MEETING NOTICE – SITE REVIEW COMMITTEE

RE: Evora, 720-730 Centerline Dr.; HB-523-6; 120 unit Leased Multi-Family Residence Development

FROM: Todd Gerbers, Director of Planning and Code Compliance

ISSUE: Discussion and action on request for a 120-unit, 2 building leased multi-family residence development with both attached and detached garage stalls.

SITE PLAN

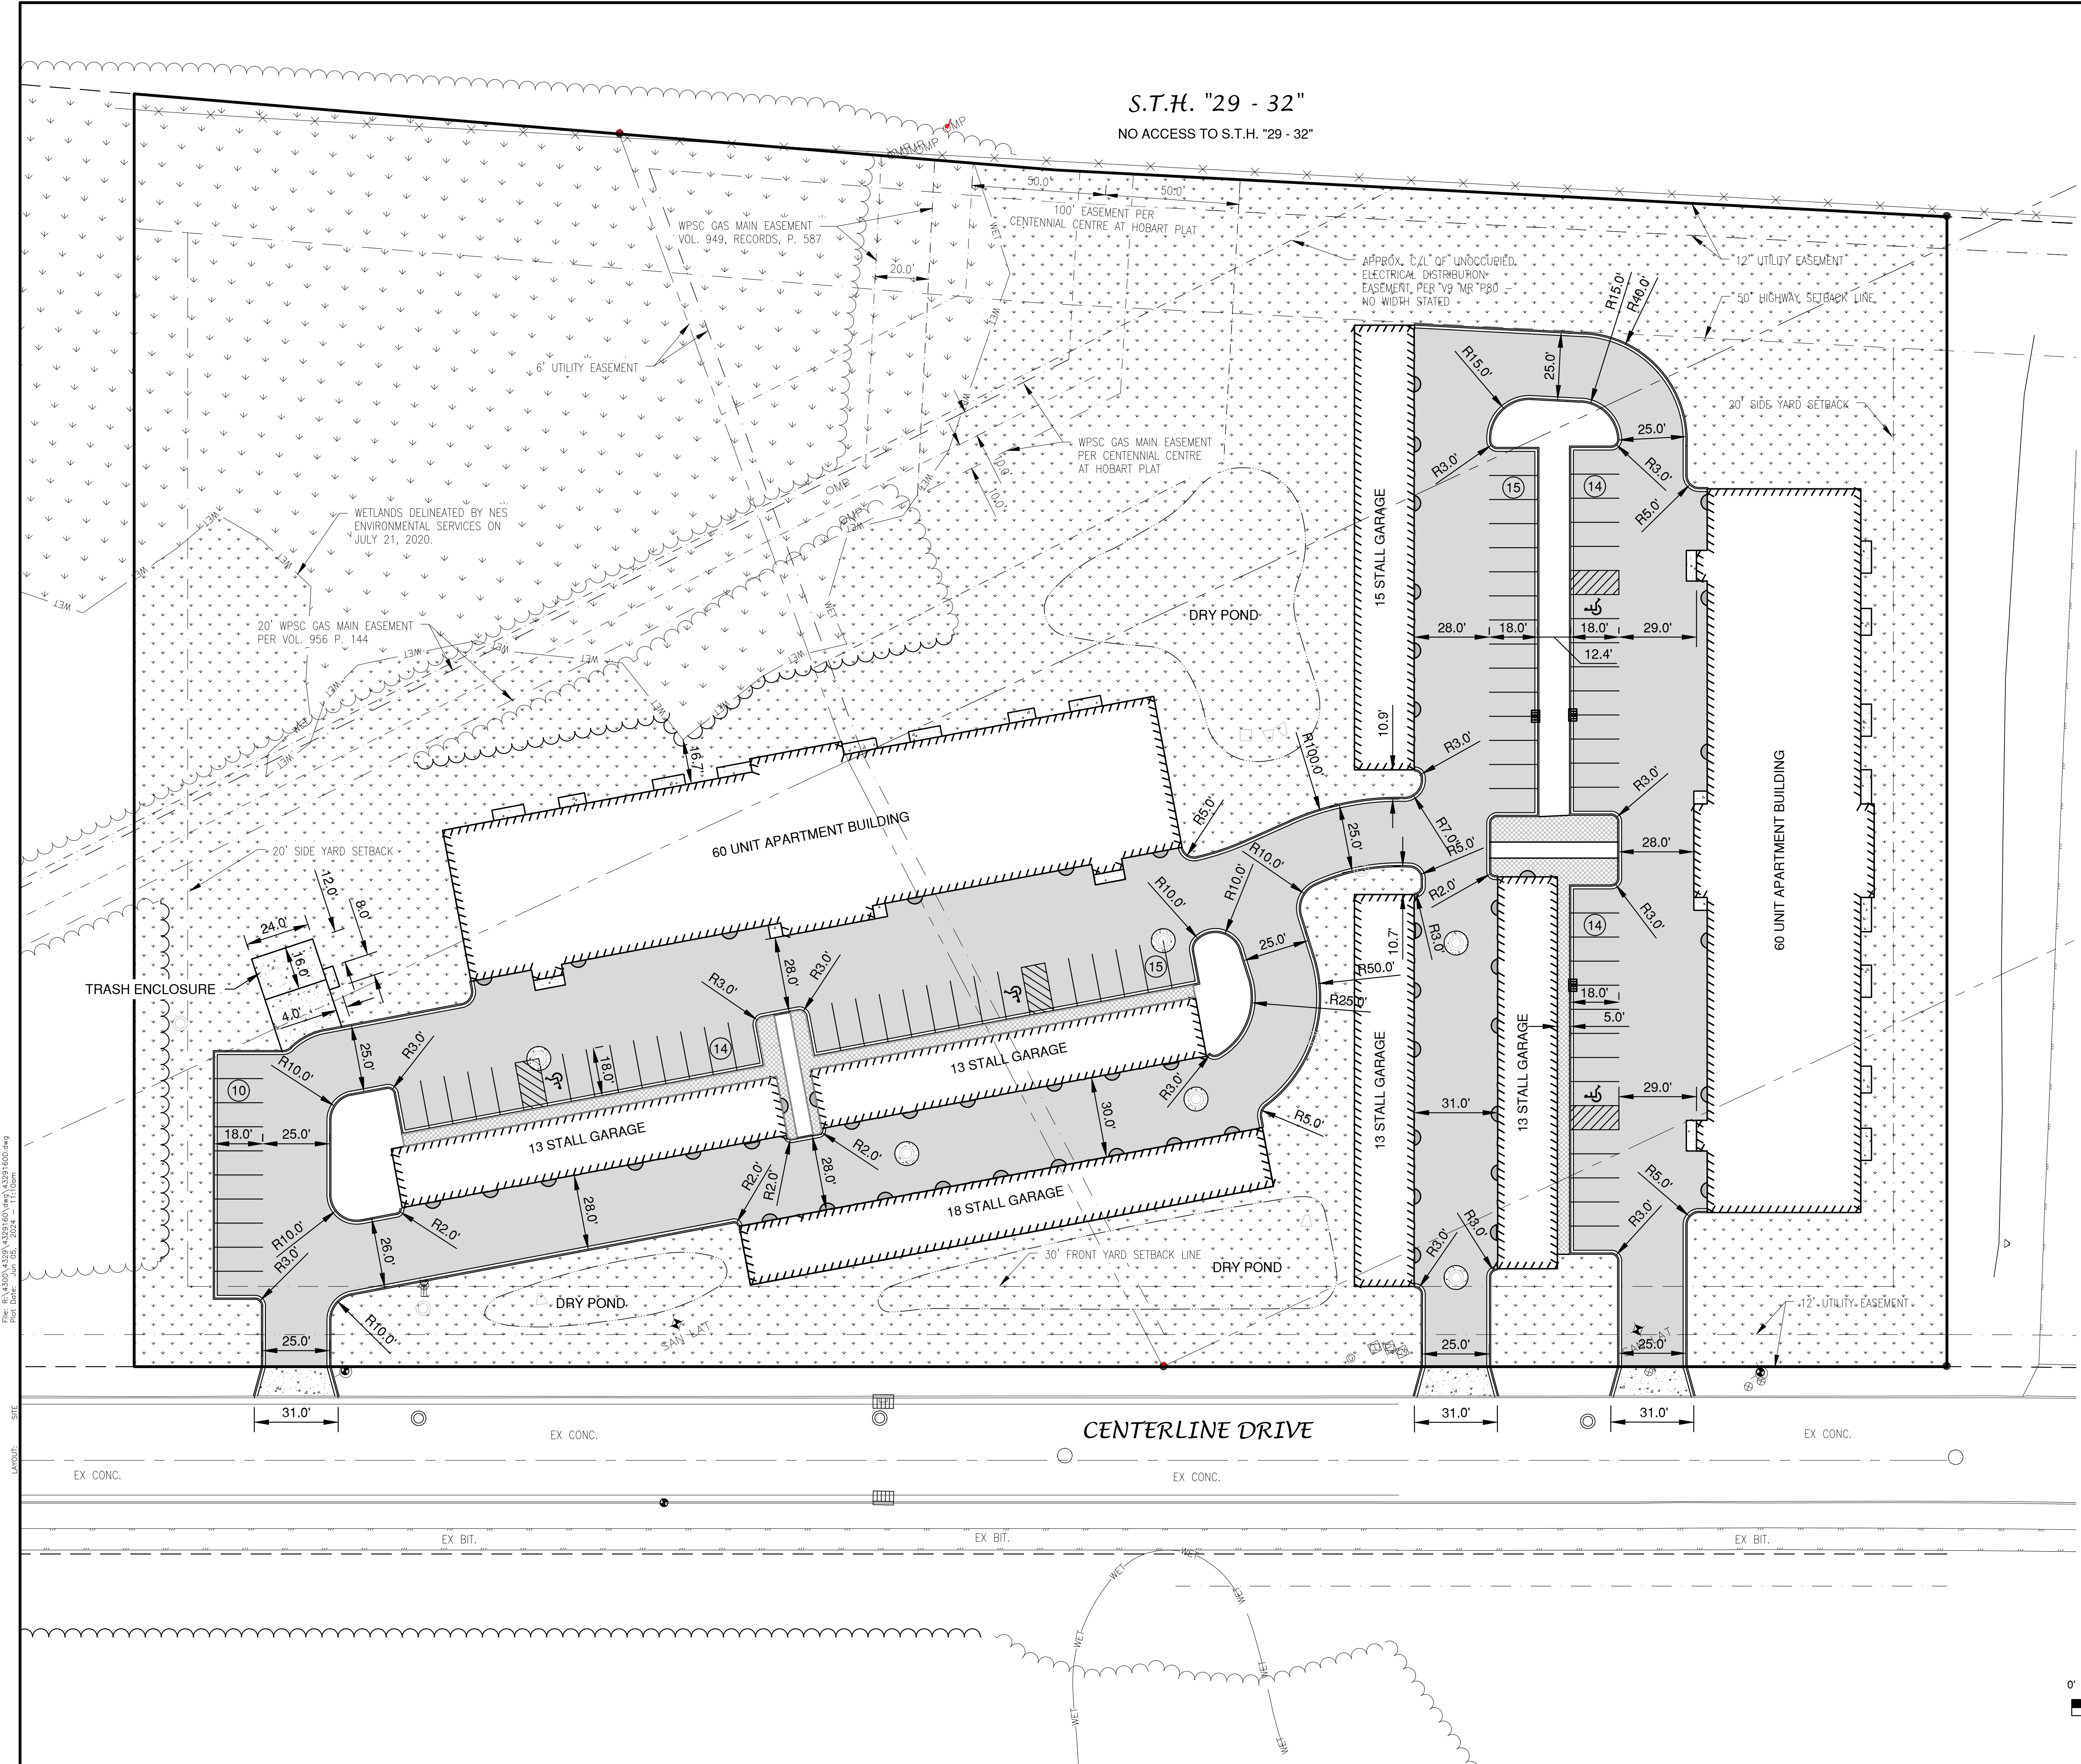
- A. Zoning:** PDD #1: Centennial Centre at Hobart District
- B. Green Space:** 58.7% green space, exceeding the 25% requirement (REL sheet 3)
- C. Setbacks:** Compliant with zoning district required setbacks (code/(proposed)) – Front 30/(30), Side 15/(25), Rear 25/(50) (REL sheet 3)
- D. Parking:** The requirements for multi-family developments are 1 and 1/2 stalls per unit plus one guest space provided for each four units and 50% of the required parking must be enclosed. Thus 210 parking stalls are required, with 105 of those being enclosed (garage stalls.) The development provides a total of 211 parking stalls with 129 of those stalls being enclosed/garage stalls. (REL sheet 3)
- E. Fire Dept. and Police Dept.:** The plans presented are in the process of being reviewed by the Police Chief and Fire Chief and any comments or concerns will be presented at the meeting.

- F. Storm Water:** Storm water from the proposed building and parking areas will be collected by storm sewer and discharge into the proposed multiple dry ponds within the development. These ponds will treat the stormwater for TSS removal and peak discharge.
- G. Refuse/Recycling Collection:** The refuse/recycling enclosure will be located to the west side of the development and consist of a 6' "metal wrapped enclosure. The use of chain-link fencing in this district is prohibited. (REL sheets 3 and 10)

1. Increase percentage of masonry and/or incorporate architectural designs to break up the tall and/or long walls of siding that face a public roadway along both end walls of easterly multi-family structure and southerly (18 stall) detached garage.
2. All exterior wall mounted HVAC grills/equipment shall be of the same color as primary structure
3. Developer providing details on the materials noted for the "metal wrapped enclosure" for the refuse and recycling enclosure.
4. Developer providing details on drive lane and driveway opening widths to Village Staff and Fire Chief for approval.
5. Lock Box location(s) to be approved by Fire Department.
